**WRITTEN REPRESENTATION FOR**  
**SPR EA1N and EA2 PROJECTS (DEADLINE 1)**  
**CONSTRUCTION - ONSHORE CABLE CORRIDOR**

**Interested Party: SASES PINS Refs: 20024106 & 20024110**

**Date: 01 November 2020 Issue: 1**

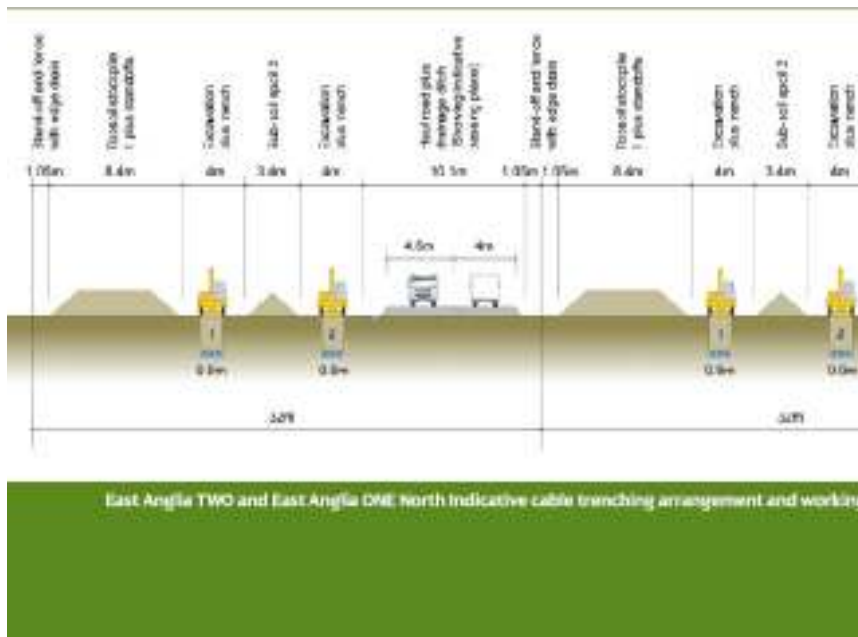
76. Along the cable route, this would mean two 32 metre wide cable corridors, each with its own two-way haul roads side by side. That would take out a 64 metres wide tranche of land, equivalent in width to almost three dual lane motorways side by side. Land use would potentially be doubled should both projects be consented.
